Access Compliance Report

Public Rights-of-Way

Intersection ID: 10041752	Main Street: WILKINSON_BV	Cross Street: N/A	Location: NW
ADA ID: 4F1DEA55BD13	Ramp Type: BlendTrans1	Initial Pass/Fail: Fail	Overall Compliance: No
		Severity Score: 8.75

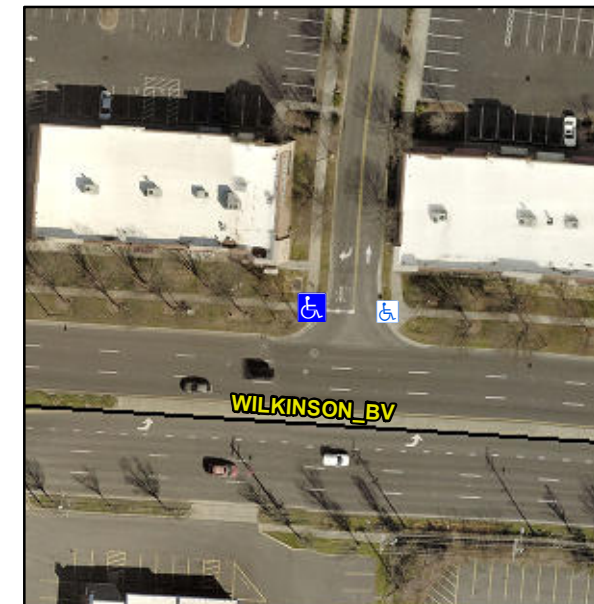
Not Found, R304.5.1

Compliance	Description	Data	Compliance	Description	Data
N/A	Ramp Length (in)	72.0	Yes	BlendTrans Slope (%)	4.3
No	Ramp Width (in)	46.0	Yes	BlendTrans XSlope (%)	0.3
N/A	Flare Type LT	N/A	N/A	Flare Type RT	N/A
N/A	Flare Slope LT (%)	N/A	N/A	Flare Slope RT (%)	N/A
N/A	Flare Traversable LT?	N/A	N/A	Flare Traversable RT?	N/A
N/A	Landing Length (in)	N/A	N/A	DWS Provided?	N/A
N/A	Landing Width (in)	N/A	N/A	DWS Contrast?	N/A
N/A	Landing Slope (%)	N/A	N/A	DWS Length (in)	N/A
N/A	Landing X Slope (%)	N/A	N/A	DWS Full Width?	N/A
N/A	Landing Curb? (Y/N)	N/A	N/A	DWS Offset (in)	N/A
N/A	Shared Landing?	N/A			
N/A	Gutter Ponding?	N/A	N/A	Gutter Slope (%)	N/A
N/A	Gutter Lip Ht (in)	N/A	N/A	Gutter X Slope (%)	N/A
N/A	Painted X Walk1?	No	N/A	Painted X Walk2?	N/A
	X Walk 1 Direction	To E		X Walk 2 Direction	N/A
	X Walk 1 Width (in)	N/A		X Walk 2 Width (in)	N/A
	X Walk 1 Slope (%)	1.9		X Walk 2 Slope (%)	N/A
	X Walk 1 X Slope (%)	0.6		X Walk 2 X Slope (%)	N/A

N/A	Ramp inside XWalk1?	N/A	N/A	Ramp inside XWalk2?	N/A
	Road Slope (%)	0.6		Clear Space?	N/A
	Road X Slope (%)	1.9	N/A	Clear Space to XWalk (in)	N/A
N/A	Any Obstructions?	N/A	N/A	Storm Grate/Utility Hazard?	N/A
	Obstruction Type			Storm Grate/Utility Type	
		N/A			N/A
			Yes	Surface Condition? (G/P)	Good
			No	Curb Slope (%)	28.3

Remove & Replace Curb Ramp With Two New Directional Ramps or Equivalent.
